HORSHAM DISTRICT COUNCIL CONSULTATION

TO:	Horsham District Council – Planning Dept
LOCATION:	Kilnwood Vale Sub-Phase 3DEFG Kilnwood Vale Crawley Road Horsham
DESCRIPTION:	Approval of details reserved by conditions 2 and 4 to approved application DC/23/0856
REFERENCE:	DISC/25/0193
RE-CONSULT:	1st set of comments in black 2nd set of comments in blue
RECOMMENDATION:	More Information No objection/Advice

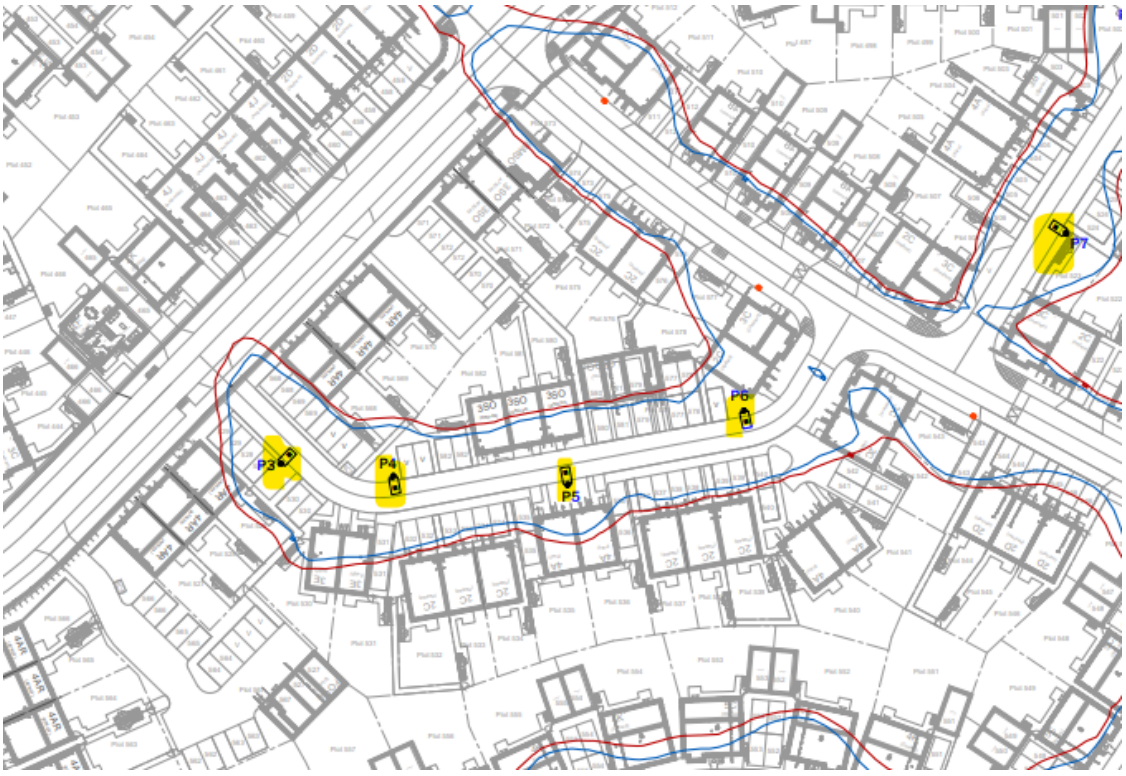
One minor point of clarification is requested however, on the area shown below. Lux levels are indicated and appear in accordance with the remaining proposed lighting columns, however no columns are detailed. It is assumed therefore that 2 additional columns are proposed within the indicated red dot locations. While we don't need to be re-consulted, it is recommended that updated plans are submitted for completeness and to be saved on file.
